**DOCKET****08-AFC-4**DATE SEP 29 2008RECD. OCT 01 2008**Record of Conversation**

Technical Area: Cultural Resources

Figure 1 A
Orange Grove Project
Location of Holocene
Alluvium and Holocene
Alluvium Outcrop

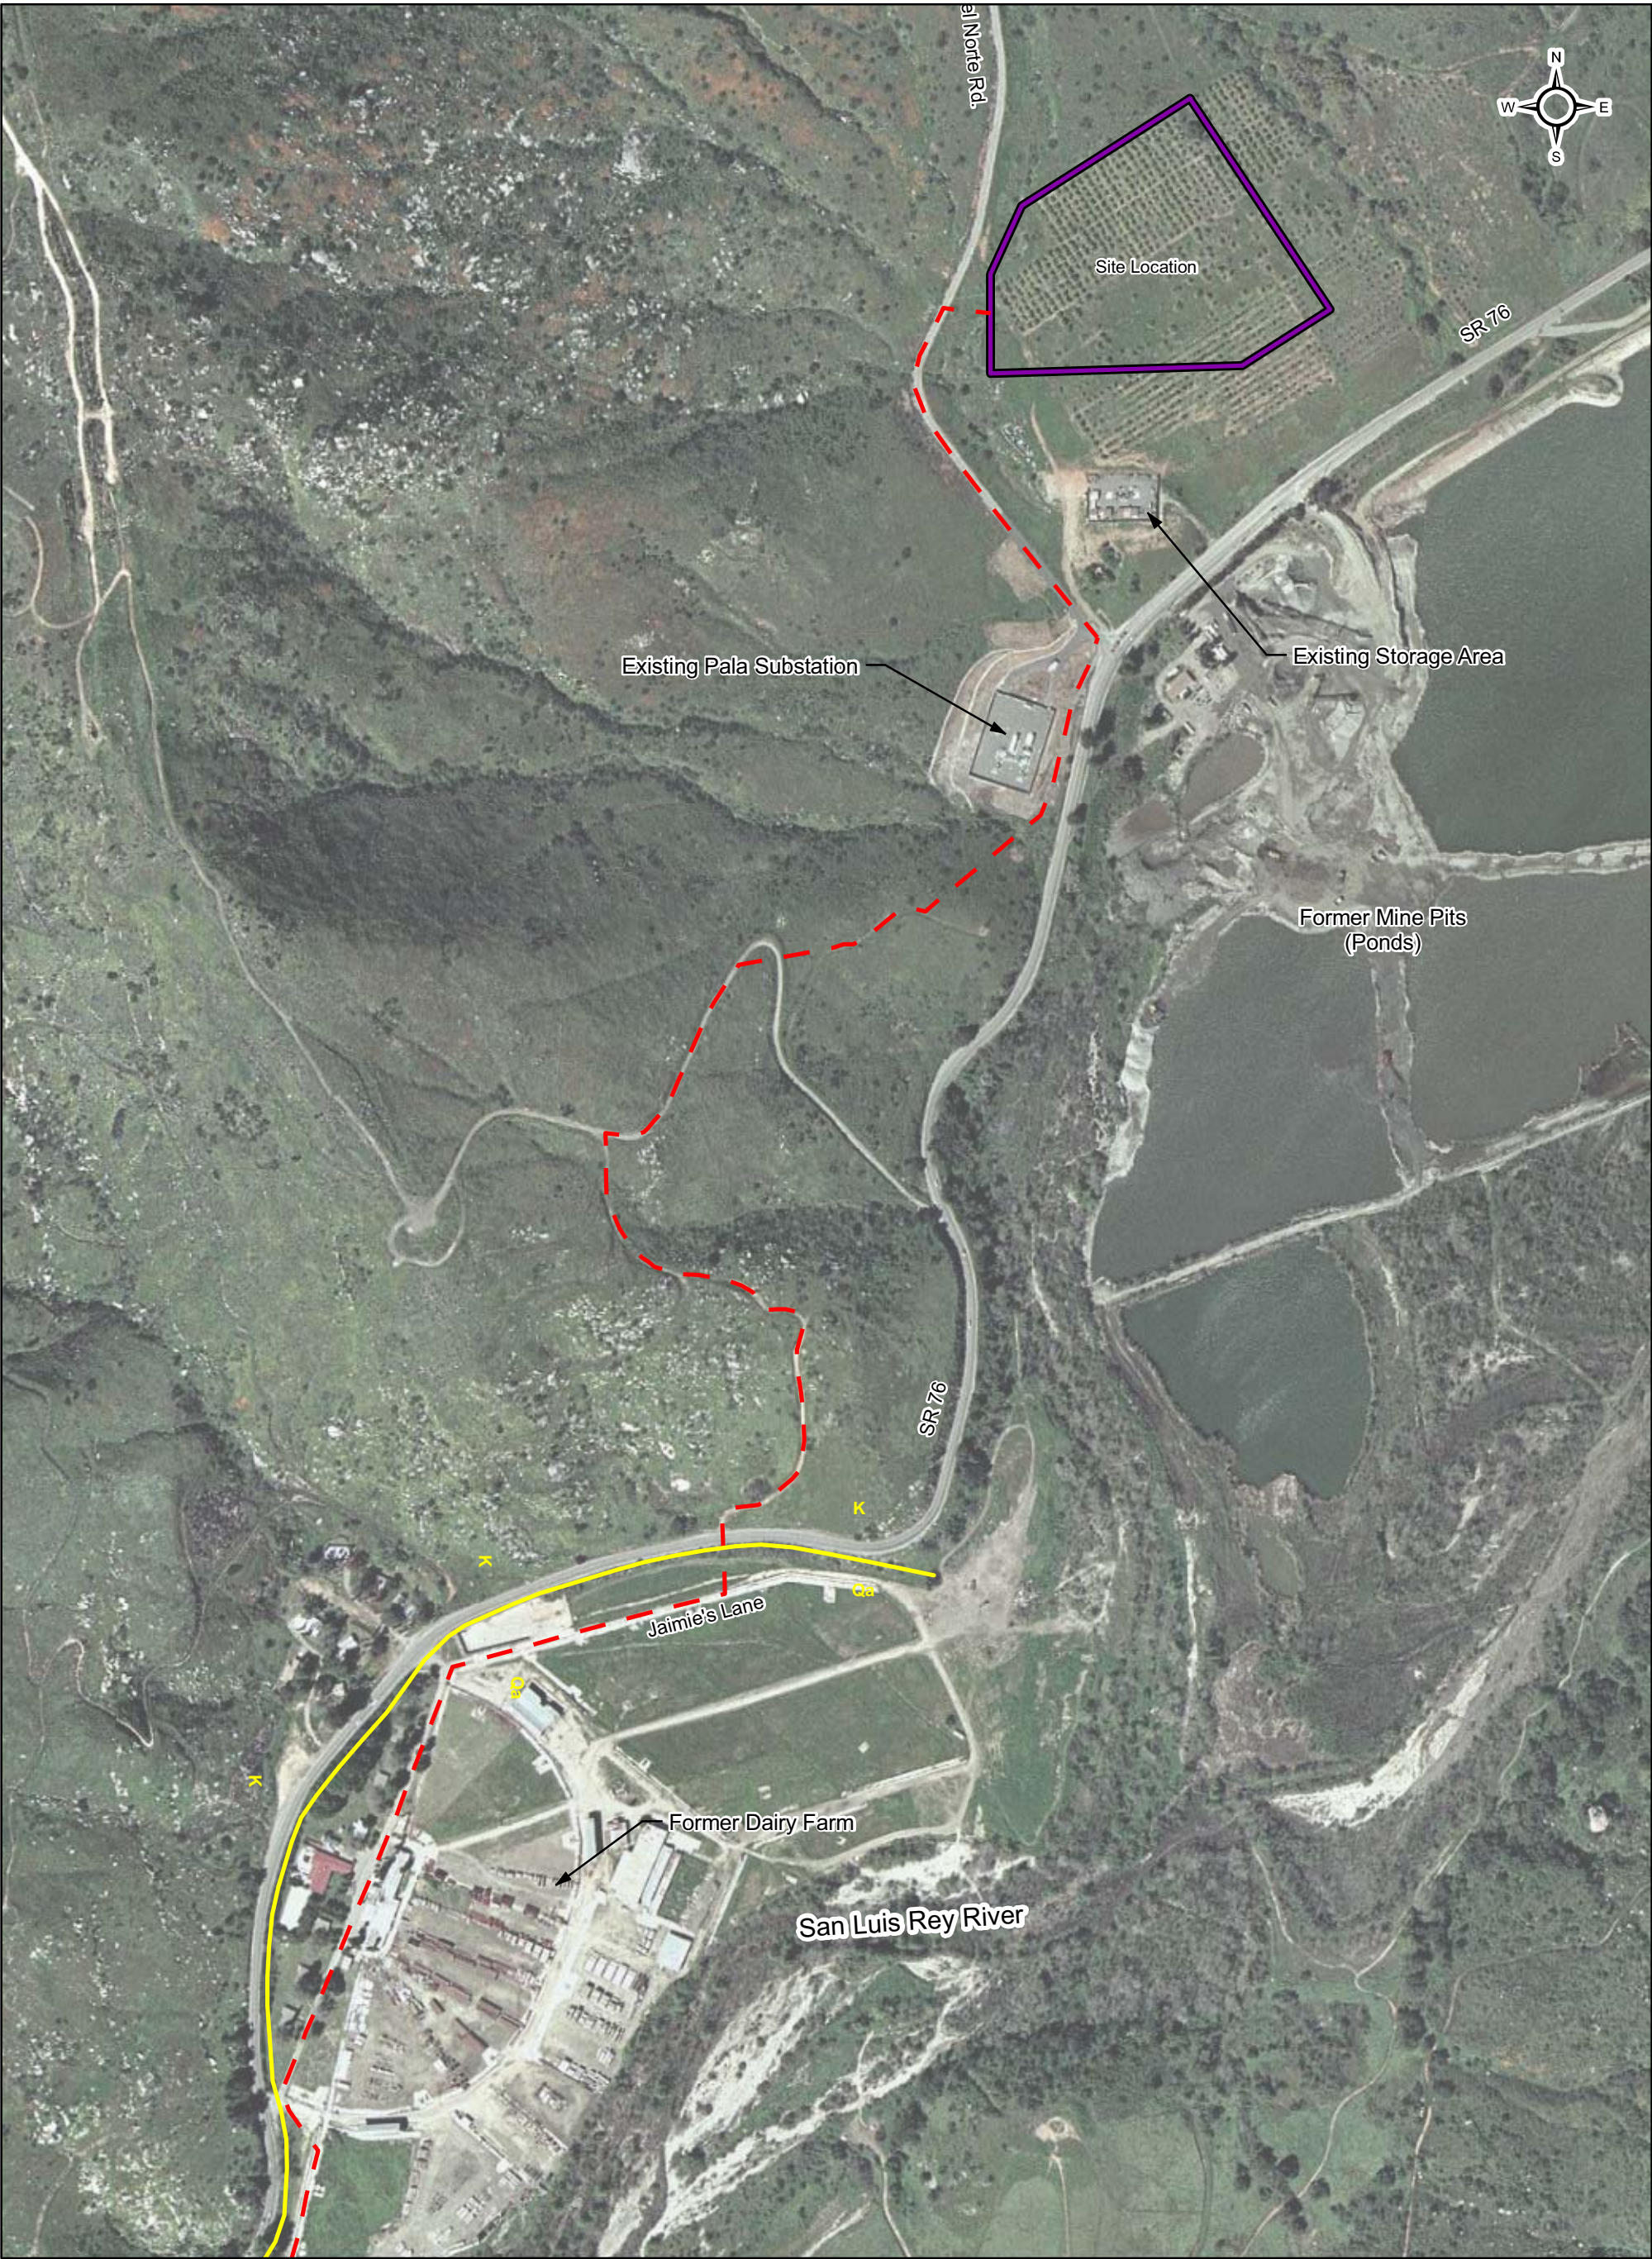
Staff requested a 1 inch = 400 foot scale map of the Holocene alluvium geologic/geomorphic unit in the vicinity of the gas pipeline.

Attachment 5 provides the requested map in two figures enumerated as Figures 1A and 1B.
